HISTORICAL LANDMARK COMMISSION STAFF REPORT

Frazier Renovation
208 E. 1th Avenue
PLNHLC2010-00377
July 7, 2010

This is a request by Steve Scoville, architect, for major alterations to a non-contributory townhome located at approximately 208 E. First Avenue in the Avenues Historic District. The request is to change the roof line, add a patio, and change the siding and fenestration. The subject property is located in the RMF-45 (Moderate/High Density Multi-family Residential) zoning district.

Elevations: Front & Rear

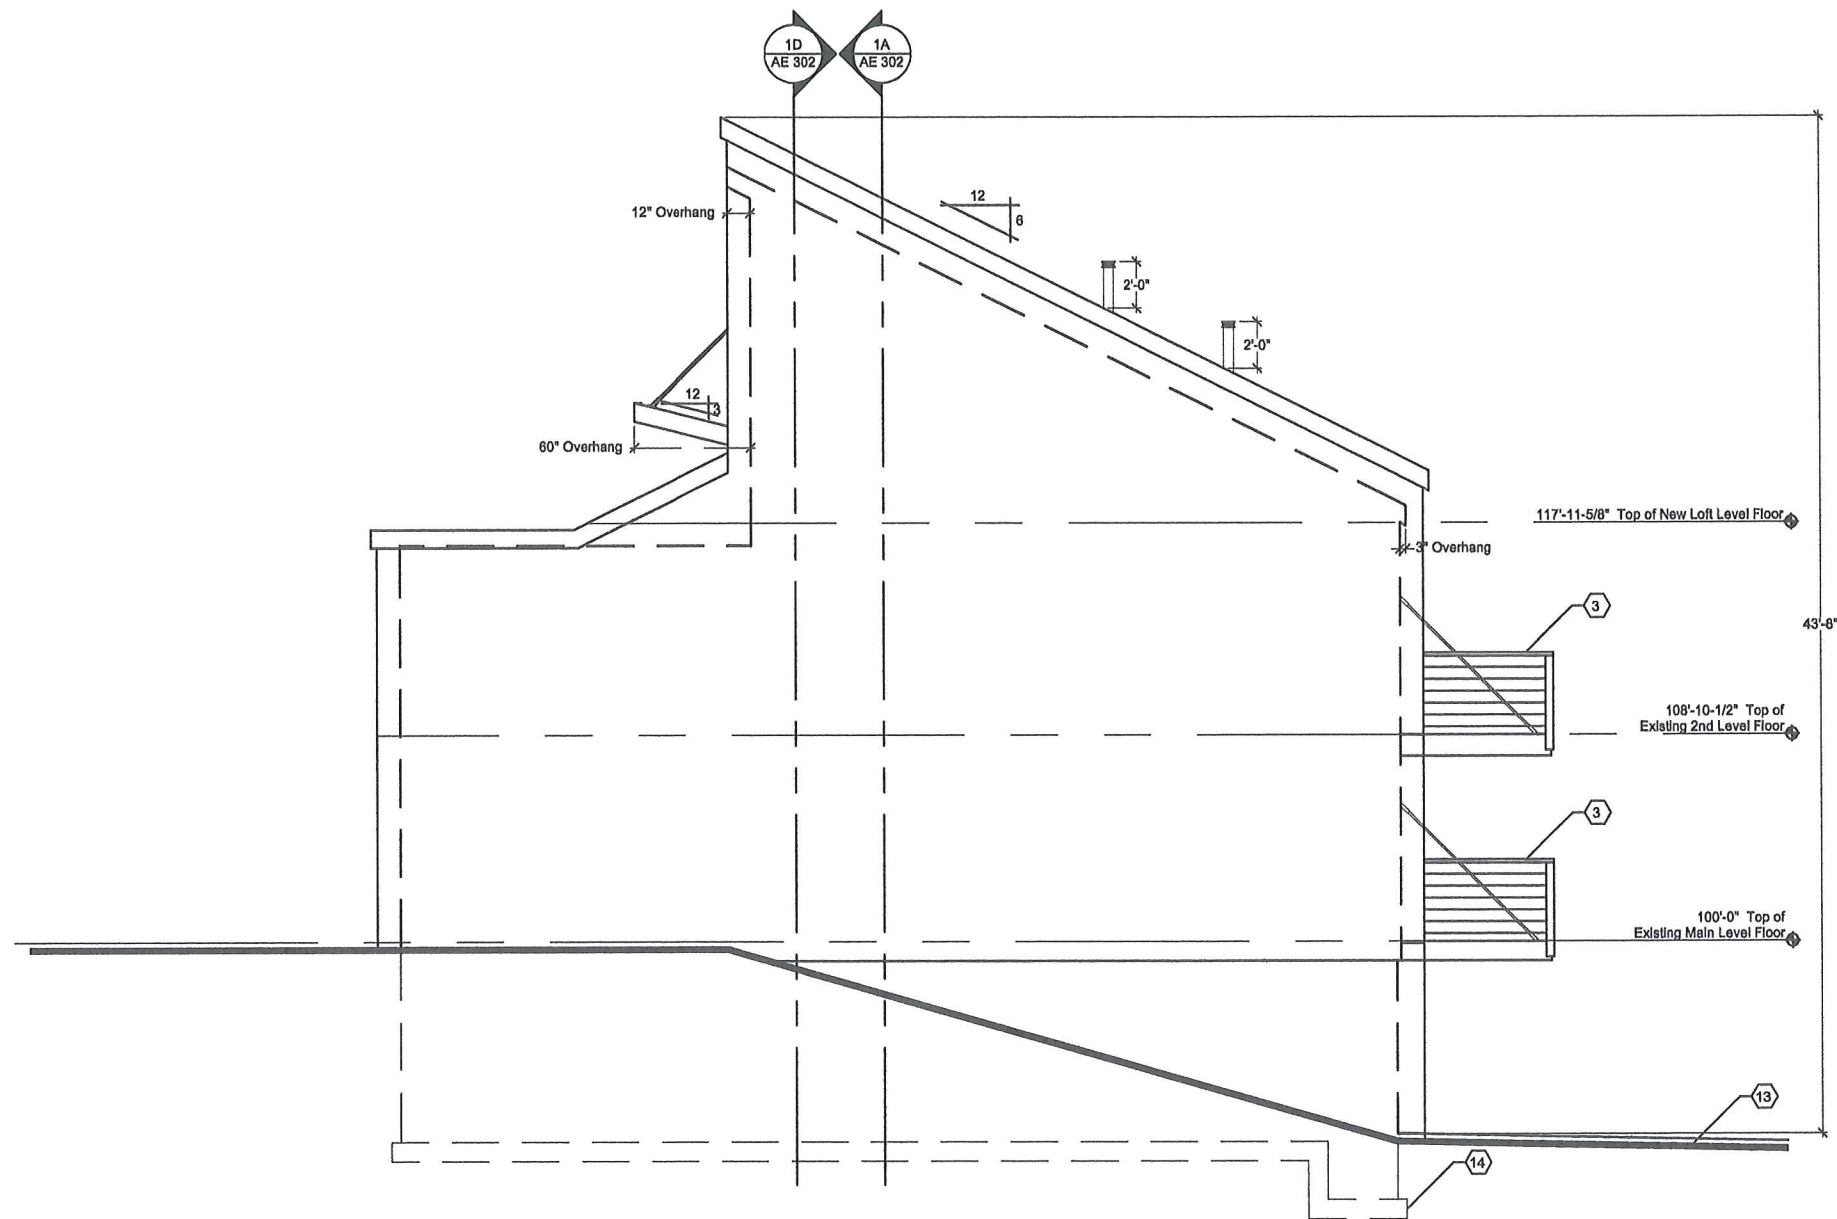
Analysis: The streetscape surrounding the subject property is comprised of many architectural styles; many of the buildings are multiple stories. This is an existing Shed style building and the footprint of the structure is not being proposed to change. However, the renovation includes change to the roof shape in the front façade from a shed roof to a flat roof and additional height due to the roof extension.

Finding: The width, mass, and scale will remain relatively the same, whereas the proposed roof line is a significant change to the façade from the surrounding structures and the streetscape.

Analysis: The renovation includes replacing and adding new windows and doors. The new windows will be asymmetrical and true to the Shed style. A portion of the front façade will have the wood cladding replaced with zinc cladding; the recessed portion of the façade will have redwood cladding. The roof will be metal with a powder coated brown finish.

Finding: The zinc cladding and the metal roof are materials that are traditionally not allowed in Historic Districts and therefore do not meet the intent of this standard.

If the Commission finds that the zinc cladding and the metal roof are not appropriate in this application, then staff recommends that the Commission deny the request, or approve it with the condition that the proposed materials will change to be consistent with what is allowed in Historic Districts.
